8122 ACTON CT

Inspection of Engineered Subsurface Wastewater System

Mecklenburg County	Carter Residence	4144B
Health Department	**Name of Establishment**	**Permit/Project No.**
8122 Acton Ct., Mint Hill, NC 28227	3-Bedroom House	360 GPD
Location	**Type of Establishment**	**Design Flow**
Christopher & Trista Carter	Same as location address	
Owner/Agent	**Address**	**Phone**
N/A		
Operator	**Address**	**Phone**
IIIb	08/29/2006	August 2011
System Type	**Date of Inspection**	**Next Inspection Due**

8122 Acton Court
Charlotte NC 28227
MCHD File Number: 4144B

PLOT

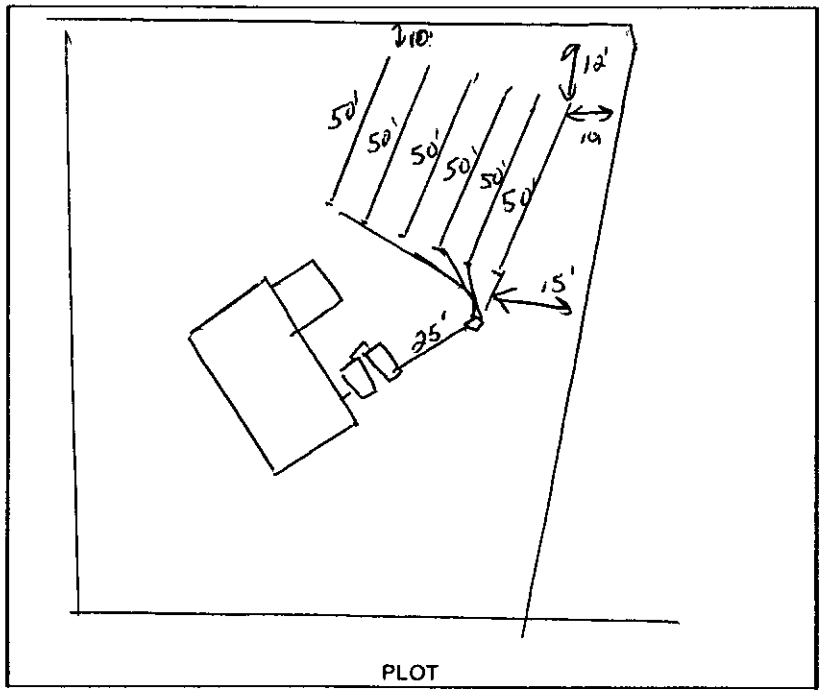
① < 2" SOLIDS IN PT

② CONTROL PANEL < 12" ABOVE GRADE
RISER < 6" ABOVE GRADE

③ HWA FLOAT NOT SECURED

(INSTALL FLOAT TREE)

PLOT OF SYSTEM

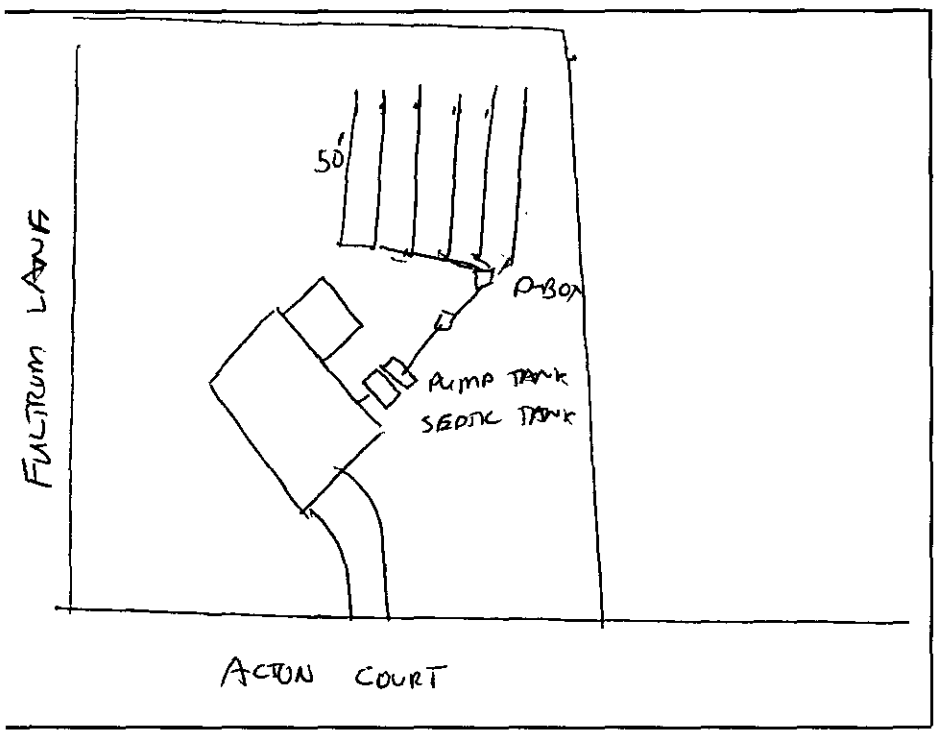
Comments: (1) INITIAL PERMIT CHANGED TO REQUIRE A PUMP AND PUMP TANK DUE TO GRADING OF LOT, ELEVATION OF PLUMBING STUB-OUT

(2) TYPE III-G INNOVATIVE

PROPOSED PLOT PLAN

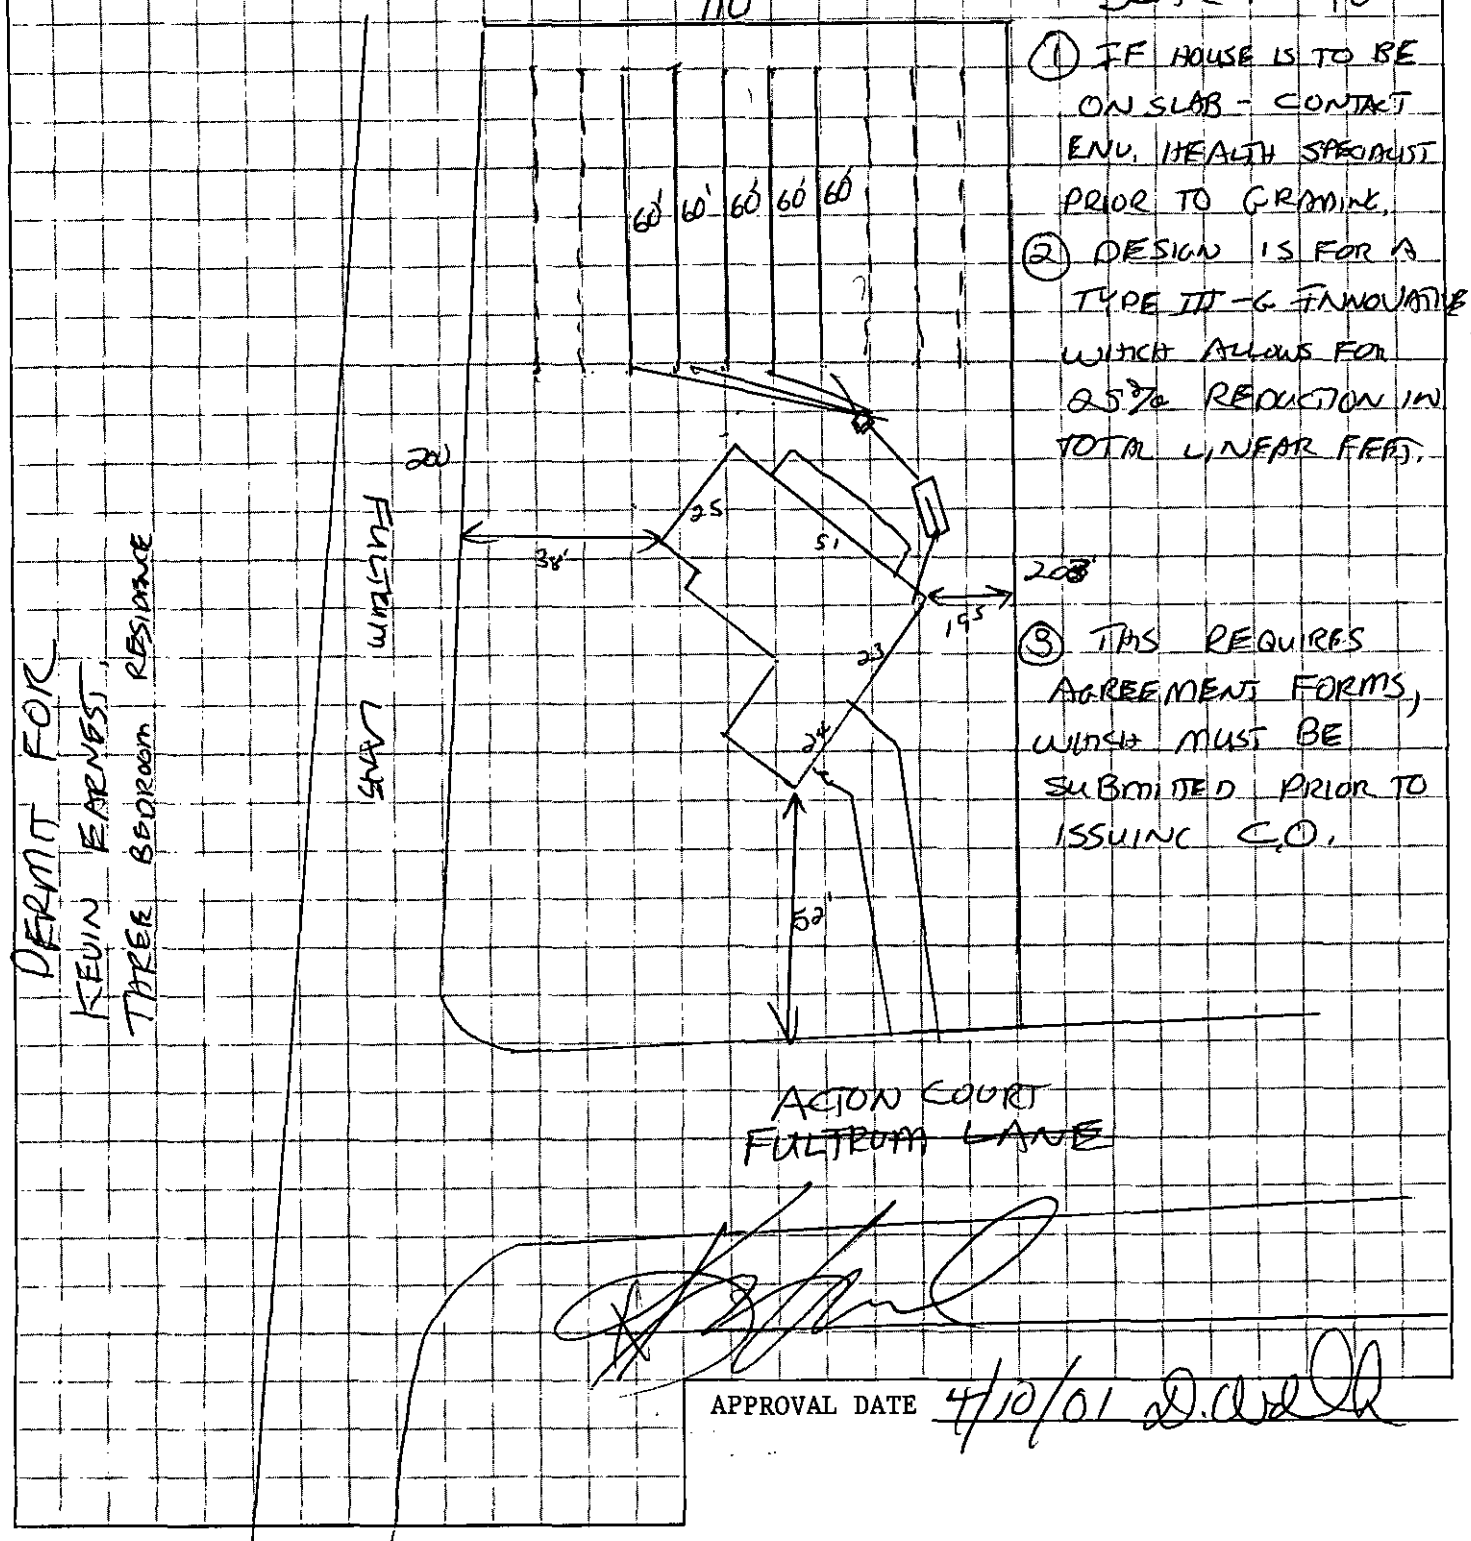
(1) IF HOUSE IS TO BE ON SLAB - CONTACT ENV. HEALTH SPECIALIST PRIOR TO GRADING.

(2) DESIGN IS FOR A TYPE III-G INNOVATIVE, WHICH ALLOWS FOR 25% REDUCTION IN TOTAL LINEAR FEET.

(3) THIS REQUIRES AGREEMENT FORMS, WHICH MUST BE SUBMITTED PRIOR TO ISSUING C.O.
